Re: Iridium Constellation LLC; Application for Modification of NGSO Mobile
Satellite Service System Authorization (S2110) To Launch and Operate
Replacement Satellites; Call Sign S2110;
File No. SAT-MOD-20131227-00148

IRIDIUM RESPONSES TO FCC QUESTIONS OF JUNE 10, 2015

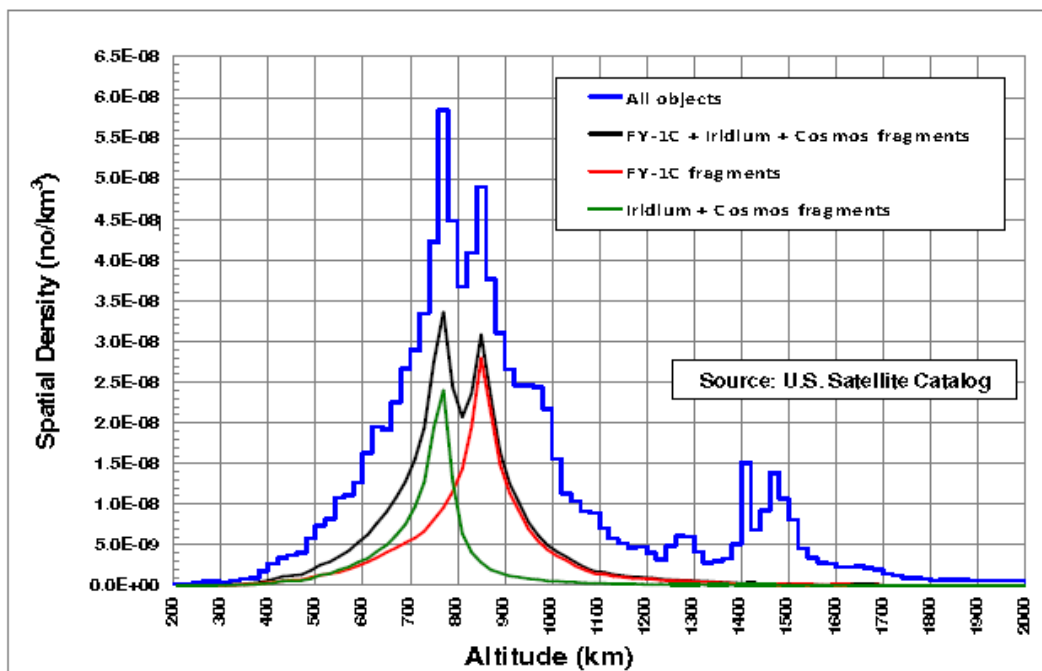
- 1. Iridium proposes to relocate second-generation satellites at end of life to a disposal orbit with an apogee altitude of 750 km and a perigee altitude of 500 km. For this disposal orbit and for alternative disposal orbits with the same apogee altitude and perigee altitudes of 450 km, 400 km, 350 km, 300 km, and 250 km, state:**
 - a. The predicted amount of time the satellite will remain in orbit following placement into the disposal orbit;**
 - b. the probability of accidental collision with space objects larger than 10 cm in diameter during that time period; and**
 - c. the effect, if any, on duration of the communications mission or on the satellite's mission capabilities in the event perigee altitudes of the disposal orbits are reduced below the proposed 500 km.**

The Iridium NEXT satellite lifetime was modeled using STELA v2.4.2, available at no charge from CNES at <https://logiciels.cnes.fr/content/stela?language=en>. Satellite dry mass is 678 kg, drag area 3.4 m². This drag area is the minimum cross section found when the solar arrays are positioned to maximize the minimum drag surface. The target disposal orbit is 750 km x 480 km, which results in a predicted orbital life of less than 25 years. These values have changed slightly since the December 2013 filing as analyses have been updated as the design matures. The disposal year was taken to be 2025, this representing a worst case value for predicted atmospheric density. Atmospheric density is variable, and driven by the Sun's 12 year activity cycle (see figure).

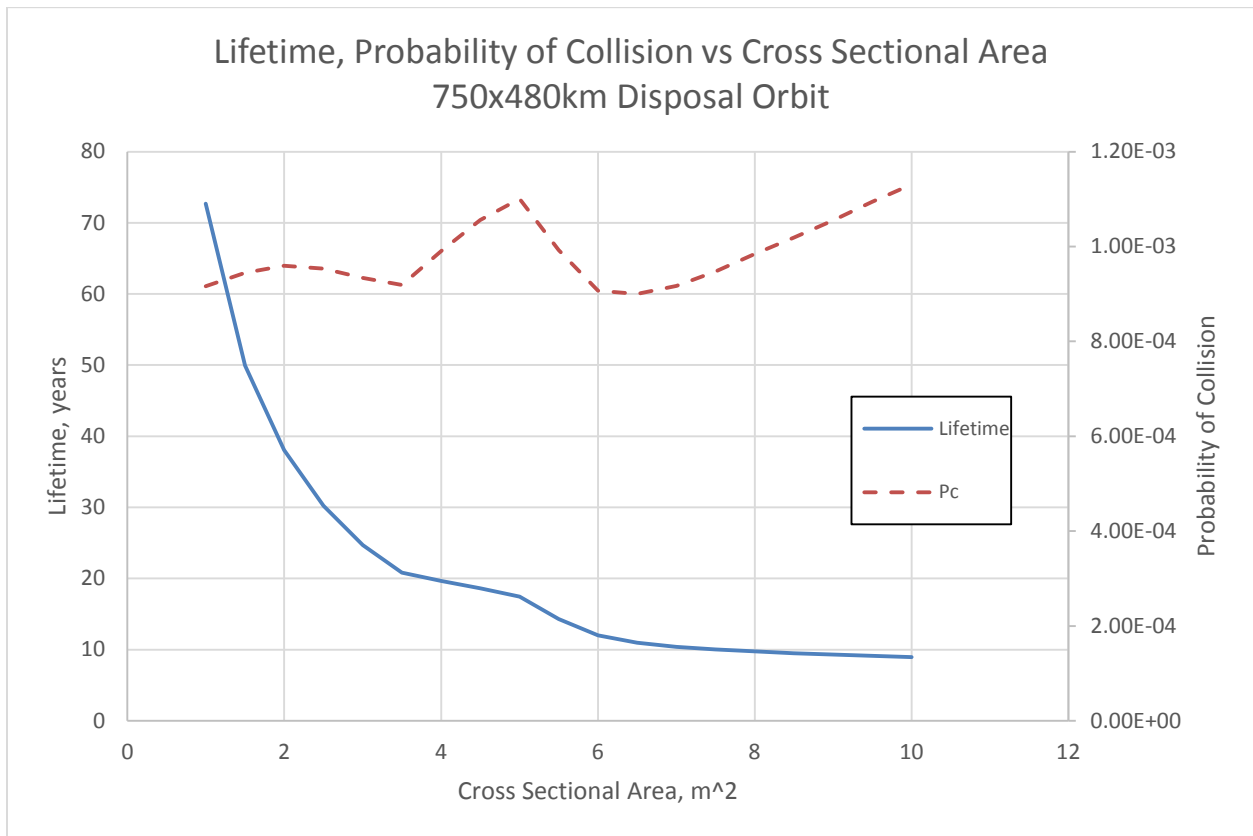
- 6. Iridium states that "[a]s part of the de-orbit process, the satellite's solar arrays will be positioned to maximize the minimum drag surface for atmospheric re-entry." Please provide further explanation. Will this disposal configuration minimize collision risk, remaining orbital lifetime, or both?**

This disposal configuration minimizes orbital lifetime, and consequently collision risk. A sensitivity study of cross sectional area as compared to orbital lifetime and collision risk was

performed using the same assumptions as outlined above. The results can be seen in the following figure:

As can be clearly seen, increasing cross sectional area dramatically decreases orbit lifetime until the area reaches roughly 6 m² (note this assumes a common mass of 678 kg in all cases), but does not strongly effect the probability of collision. This is due to the fact that the probability of collision is a function of cross sectional area and time, not cross sectional area alone.
